UNITED STATES OF AMERICA
NUCLEAR REGULATORY COMMISSION

Application of SOUTHERN CALIFORNIA)	Docket No. 50-361
EDISON COMPANY, <u>ET AL.</u> for a Class 103)	
License to Acquire, Possess, and Use)	
a Utilization Facility as Part of)	Amendment Application
Unit No. 2 of the San Onofre Nuclear)	No. 156
Generating Station)

This amendment application consists of Proposed Change Number (PCN)-454 to Facility Operating License No. NPF-10. PCN-454 revises the acceptance criteria for the Agastat time delay relays used in the Engineered Safety Features (ESF) load sequencer in Surveillance Requirement (SR) 3.8.1.18, "A.C. Sources - Operating" of Technical Specification (TS) 3.8.1, "A.C. Sources - Operating." The Bases of SR 3.8.1.18 will also be revised.

DESCRIPTION AND SAFETY ANALYSIS
OF PROPOSED CHANGE NPF-10/15-454

FIGURE 1

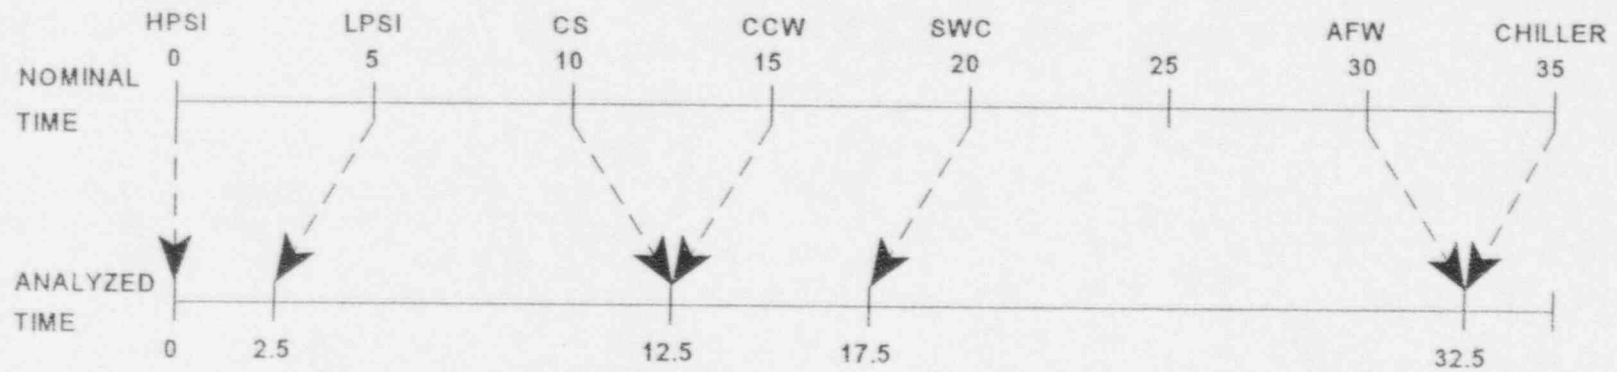
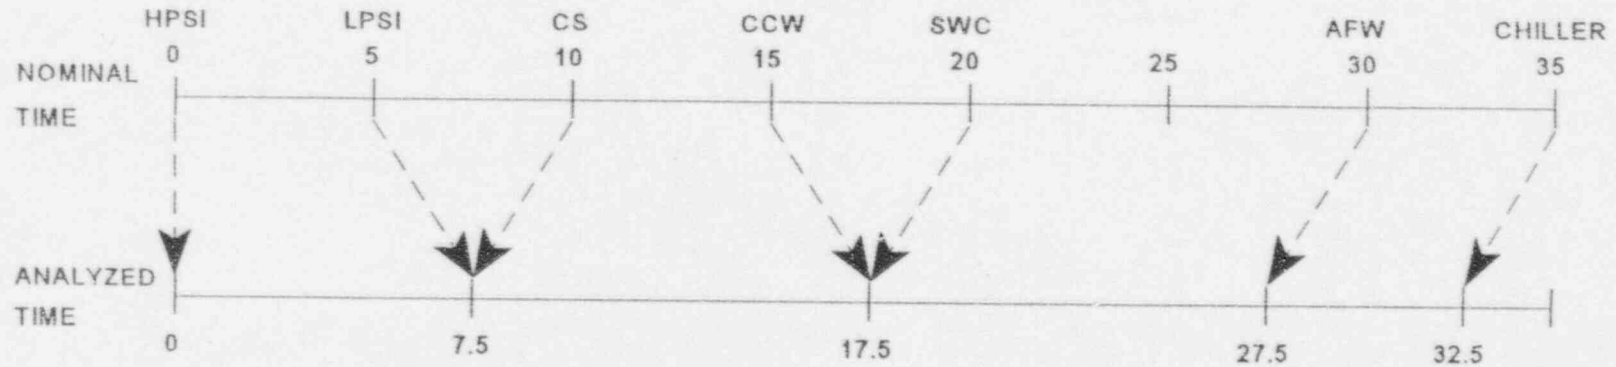
Electrical system performance has been analyzed by performing dynamic voltage analyses assuming a timer tolerance of ± 2.5 seconds for all load groups. A tolerance of ± 2.5 seconds creates the possibility of overlap of adjacent load groups (i.e., one load group starts 2.5 seconds late and the following load group starts 2.5 seconds early, resulting in two load groups starting at the same time). Figure 1 illustrates this. All possible combinations of adjacent load groups overlapping have been evaluated and shown to be acceptable with respect to electrical system and DG performance. These analyses are documented in Reference 1 and are included as part of Attachment E.

Although a tolerance of ± 2.5 seconds for the 5 second load group is acceptable with respect to the loading capability of the DGs, the as-found tolerance for this load group will be -0.5, +2.5 seconds. This ensures that the voltage transient due to starting this load group when powered from the offsite source will not interfere with the Loss of Voltage/Degraded Grid Voltage with SIAS (LOVS/DGVSS) circuitry. The LOVS/DGVSS circuit senses the 4 kV bus voltage just prior to time $T = 4.5$ seconds and transfers the bus to the DG if the voltage is below the degraded voltage setpoint. If the 5 second load group were to start prior to $T = 4.5$ seconds, the resulting voltage dip could appear to be a degraded voltage condition, and cause an undesirable actuation of the DVGSS relay scheme. To avoid this potential interference, the as-found tolerance for early starting of the 5 second load group will be restricted to -0.5 seconds. The acceptable as-found tolerance is therefore -0.5, +2.5 seconds.

FIGURE 2

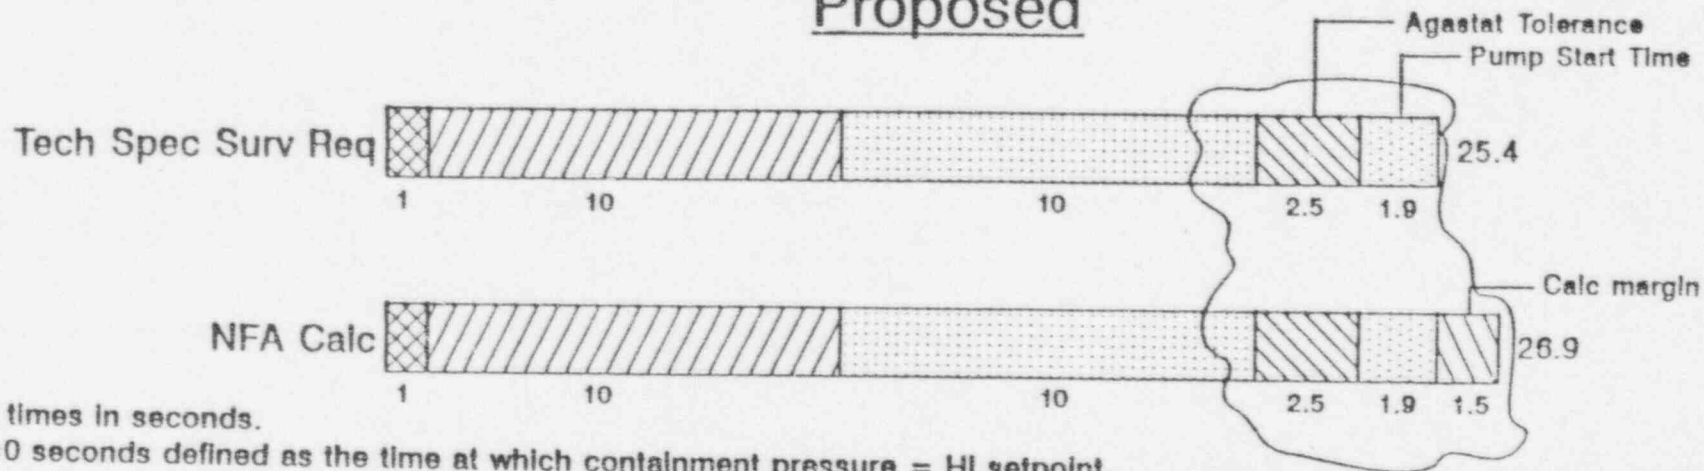
For example, the existing analysis for the Containment Spray system, the most limiting system, demonstrates that an overall system response time of ≤ 26.9 seconds is acceptable. This

analysis allocates 1.0 second for timer tolerance, 4.0 seconds for pump acceleration, and includes additional unallocated margin of 0.9 seconds. These intervals can be reallocated as follows with no overall increase to the system response time: 2.5 seconds for timer tolerance, 1.9 seconds for pump acceleration, and 1.5 seconds of unallocated margin. Figure 2 provides this comparison between the Technical Specification required response time for the pump and calculational basis (both existing and proposed) which justifies the changes.

Agastat tolerance can be increased to ± 2.5 sec. Overall response time is unchanged.
